Access Compliance Report Public Rights-of-Way (Curb Ramps)

Main Street: MEREDITH_DR Cross Street: LORETTA_DR Location: NW

ADA ID: RPAT210930095301 Ramp Type: Type 1 - Perpendicular Diagonal Initial Pass/Fail: Pass Overall Compliance: No Severity Score: 26

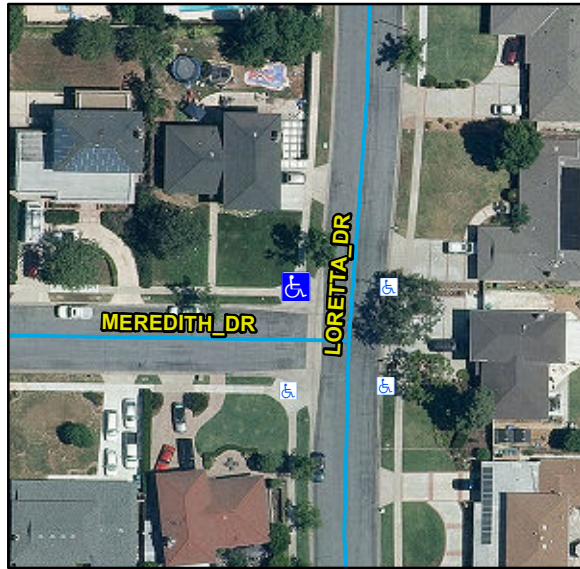
Compliance	Description	Data	Compliance	Description	Data
N/A	Ramp Length (in)	128	N/A	Flare Type LT	
Yes	Ramp Width (in)	61			Sloped
Yes	Ramp Run Slope (%)	7.7	N/A	Flare Slope LT (%)	4.9
Yes	Ramp Cross Slope (%)	1.5	N/A	Flare Traversable LT	No
N/A	Landing Present	No	N/A	Flare Type RT	
N/A	Landing Length (in)	N/A			Sloped
No	Landing Width (in)	N/A	N/A	Flare Slope RT (%)	7.4
No	Landing Run Slope (%)	N/A	N/A	Flare Traversable RT	No
No	Landing Cross Slope (%)	N/A	No	DWS Provided	No
N/A	Landing Movement Obstructed?	No	N/A	DWS Contrast	N/A
	Landing Movement Type	N/A	N/A	DWS Length (in)	N/A
N/A	Landing Shared	N/A	N/A	DWS Full Width	N/A
N/A	Clear Space	Yes	N/A	DWS Offset Left (in)	N/A
N/A	Clear Space To Crosswalk (in)	48	N/A	DWS Offset Right (in)	N/A
N/A	Marked Crosswalk 1	No	N/A	Marked Crosswalk 2	No
	Crossing 1 Direction	S		Crossing 2 Direction	E
	Marked Crosswalk 1 Width (in)	N/A		Marked Crosswalk 2 Width (in)	N/A

N/A	Ramp Inside Crosswalk 1	N/A	Yes	Ramp Inside Crosswalk 2	N/A
	Crossing 1 Slope (%)	0.8		Crossing 2 Slope (%)	4.5
	Crossing 1 Cross Slope (%)	5.3		Crossing 2 Cross Slope (%)	2.1
Yes	Gutter Ponding	No	No	Curb Slope	9.6
Yes	Gutter Lip Height (in)	0		Road Run Slope (%)	0.2
No	Gutter Run Slope (%)	5.5		Road Cross Slope (%)	4.3
Yes	Gutter Cross Slope (%)	0.3			
Yes	Overall Surface Condition: Acceptable		No	Perp Joint Present	No
	Cross Gutter Present?	Yes		Spandrel Present?	Yes
	Replace Cross Gutter?	No		Replace Spandrel?	No

Remove & Replace Curb Ramp With Two New Directional Ramps or Equivalent. Remove & Replace Gutter.
